City of Santa Fe, New Mexico

memo

2026-012105-HDRB, 1103 Canyon Rd. Downtown & Eastside Historic District, contributing, Thomas Gifford Architect LLC, agent for GypHills, LLC, owner, requests status review with primary façade designation, if applicable, for a residential structure.

Figure 3: Façade diagram

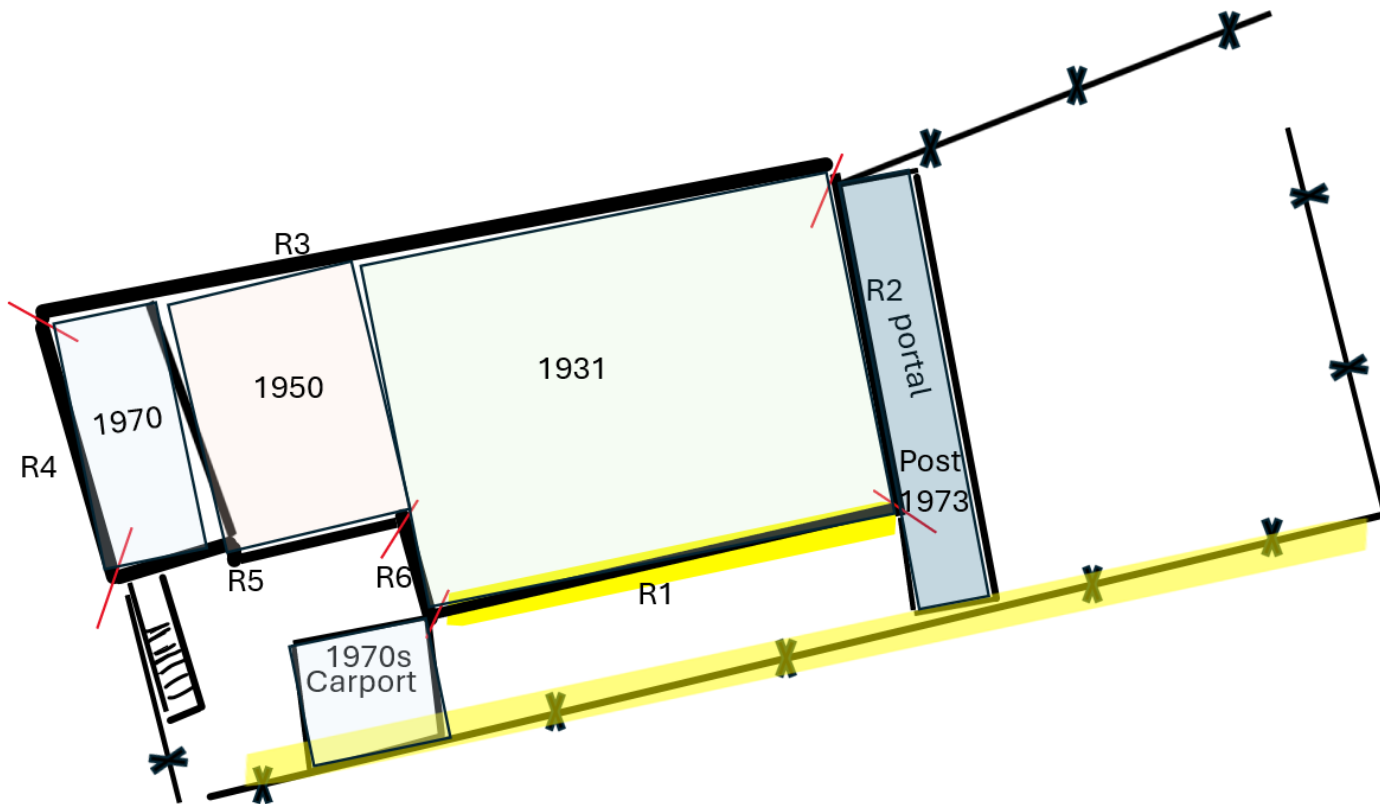
The building's overall ground plan remains consistent, and the overall massing has minor impacts on the historic integrity, such as the 1970s addition on the west, the removal or alteration of windows along the north elevation,

and the introduction of ventilating-type sashes, which have altered the building's presentation of its historic period and associations. Therefore, staff find that the structure should be retained as a contributing structure.
